SUBJECT: Bruce Hoch  
Development Permit / 10164 Williams  
Road DATE: July 22, 2024

DEPARTMENT: Planning Department  
DP001729 PREPARED BY: Krista Goodman /mb

## STAFF REPORT ON DEVELOPMENT PERMIT DP001729

Previously Approved Elevations as per DP001423

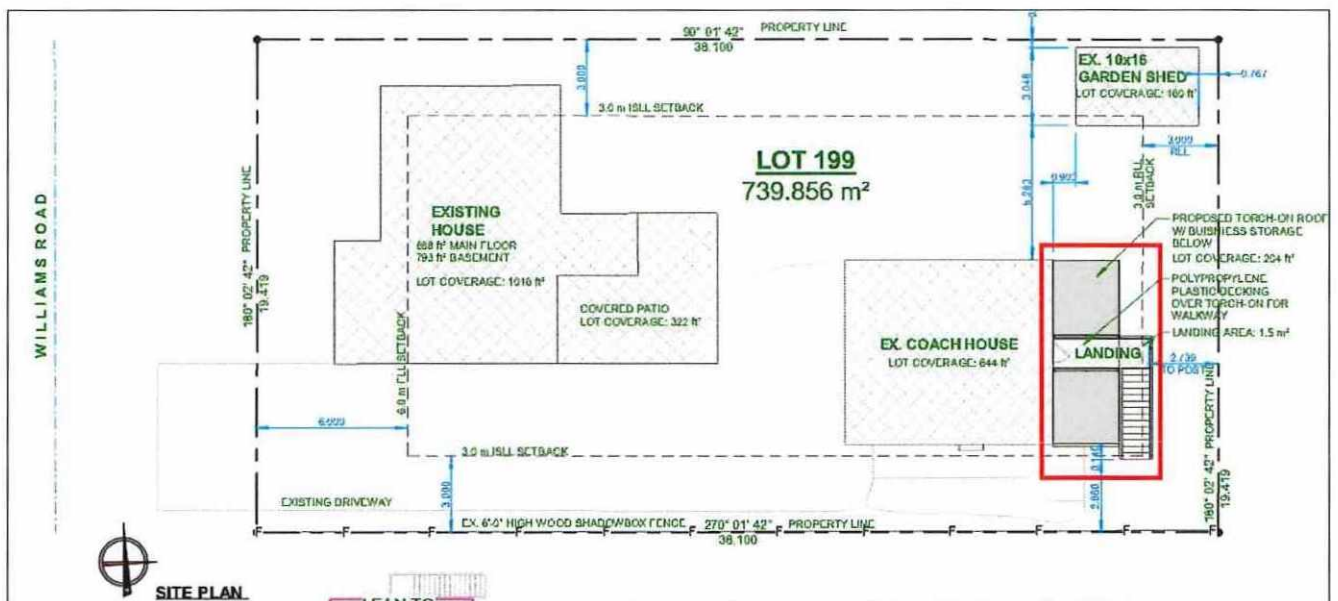
As detailed in the attached checklist and Section 4 of this report, the applicant is requesting a departure to the DPA10 Design Guidelines to allow the deck to be oriented toward the rear lot line instead of the principal dwelling. As this application diverges from Design Guideline requirements, consideration by Council is required.

The applicant is requesting a departure to the Design Guidelines through the Development Permit application process. The Guidelines specify that coach house decks are to be oriented towards the principal dwelling unit to protect the privacy of adjacent properties. The applicant is in the process of constructing a deck and enclosed storage area oriented towards the rear lot line and away from the existing principal dwelling, as shown in red below. While the original approved design included a staircase entry at the rear of the building, the size and scale of the recent construction are not consistent with the previous approval and have the potential to negatively impact the adjacent property.

Originally, the applicant proposed to utilize the entire addition as a large deck area; however, the applicant now proposes to relocate the railings to create a landing area and reduce the impact on the property to the east. Although the applicant has minimized the deck space by relocating the railings, there remain privacy concerns and overlooking of the adjacent property. Given the departure from the design guidelines, staff are not supportive of this request and recommend that Council deny the issuance of the draft Development Permit.
